RE: Parker and Pine F1 L1: In-N-Out Burger
Formal Site Plan Application – 1st Submittal Review Comments – SP22-143
Fire & Life Safety

Plan Review Summary:

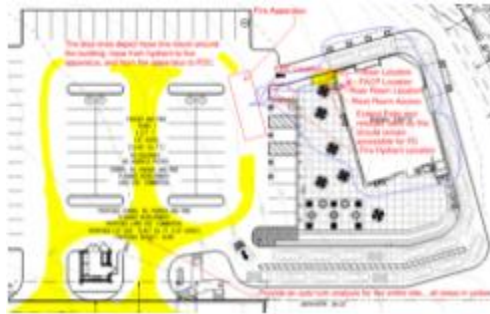
6. A sidewalk shall be extended to the riser room door as well as the FDC; a 5'x5' pad shall be provided in front of the FDC. Address this issue when resubmitting.

Response: The concrete patio encompasses the riser room to satisfy this comment. Please clarify if additional changes are required.
